## Bryton – Corporate Center Subdivision Sketch Plan

### PART 1: PROJECT SUMMARY

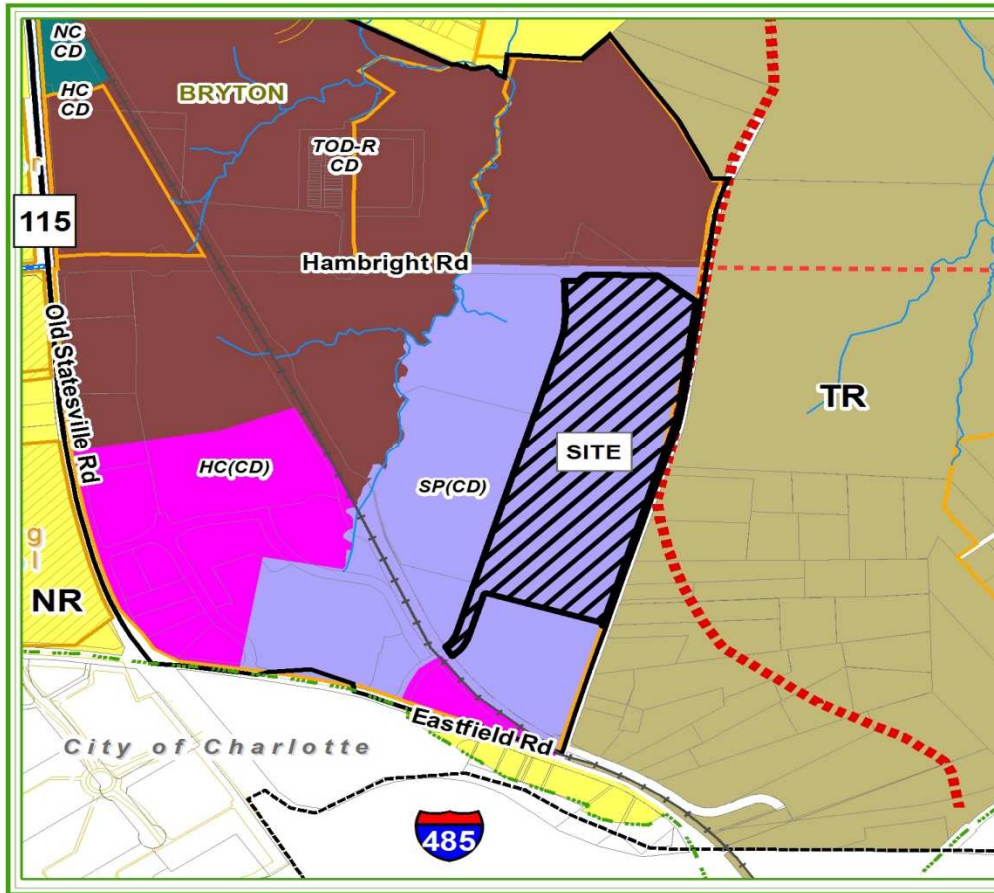
1. The proposed subdivision sketch plan has 5 lots on 35.95-acres, as shown in the hatched area above. The subdivision sketch plan also includes an existing 13.4-acre lot south of Savoy Drive, which is an existing lot of record, created in 2012 when the two (2) new streets were platted. The new lots range in size from 6.4-acres to 7.8-acres.
